Friends 4 Expo Transit
P.O. Box 64943
Los Angeles, CA 90064
mail@friends4expo.org
www.friends4expo.org

Comments on the Expo Line Phase 2 Draft EIR

March 25, 2009

San Jose aerial light rail structure example for Sepulveda and Olympic

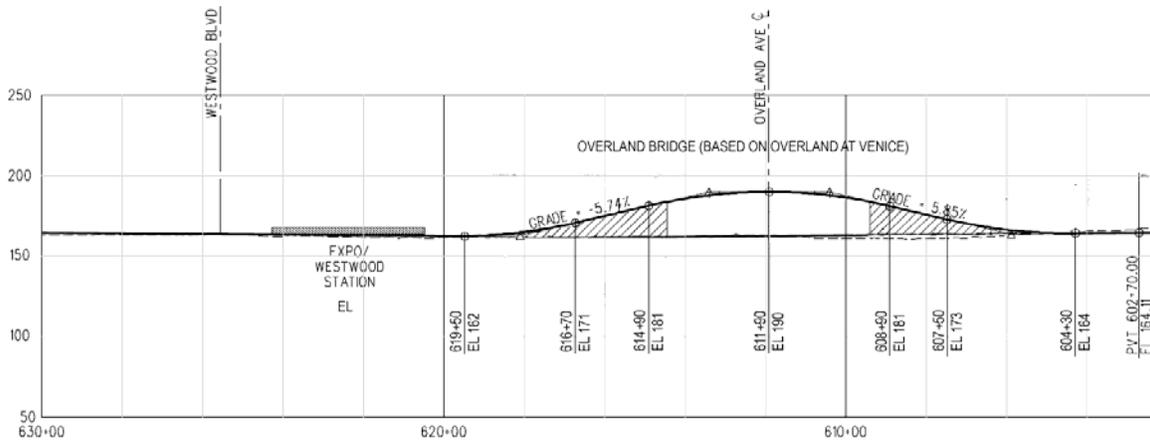
The photo on page 3 of aerial light rail along Capitol Avenue in San Jose gives an indication of the impact of elevating Expo along Sepulveda or Olympic. Not to mention property takes and loss of many mature street trees.

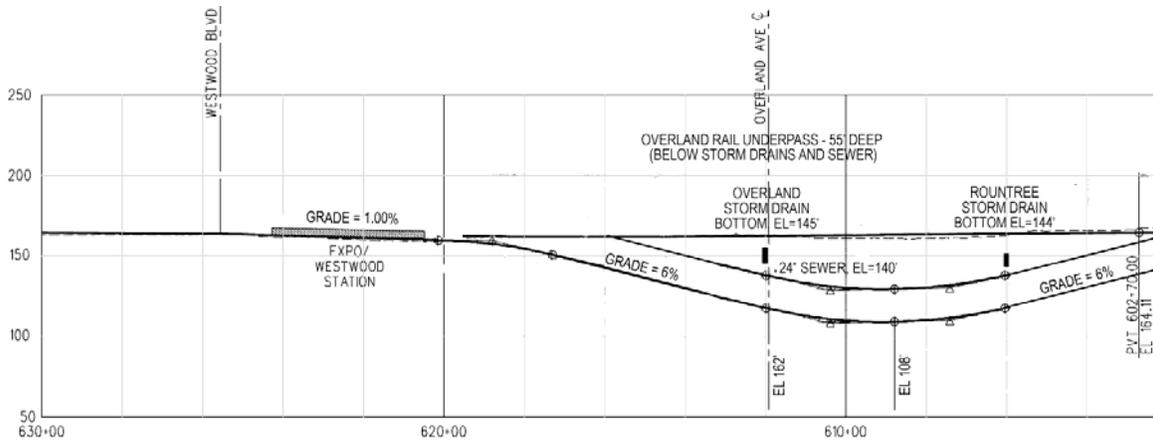
A. We'd recommend a **rail bridge** be as low as possible to reduce visual impact (including removing the existing hump on Overland at the old railroad crossing), combined with landscaping and natural slopes in lower parts of its ramps. The image below shows its ramp from Richland and Selby.

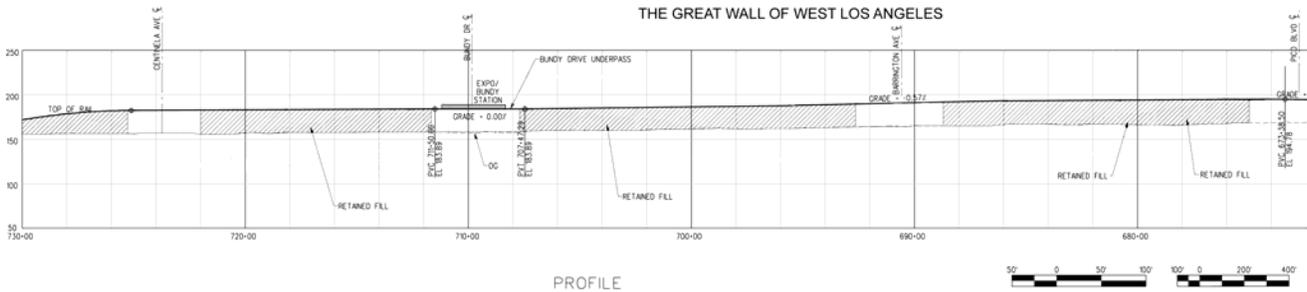
9. We support the **at-grade crossing at Westwood**, noting that LADOT's only objection was loss of street parking, and the width of only *one to four lots* hardly constitutes the “severe inconvenience” of “extensive walking distances”.
10. Here is a photo of southbound traffic on **Centinela** stopping across Expo during a typical PM commute. Will queue-cutter signal plans work here (page 3.2-25)?
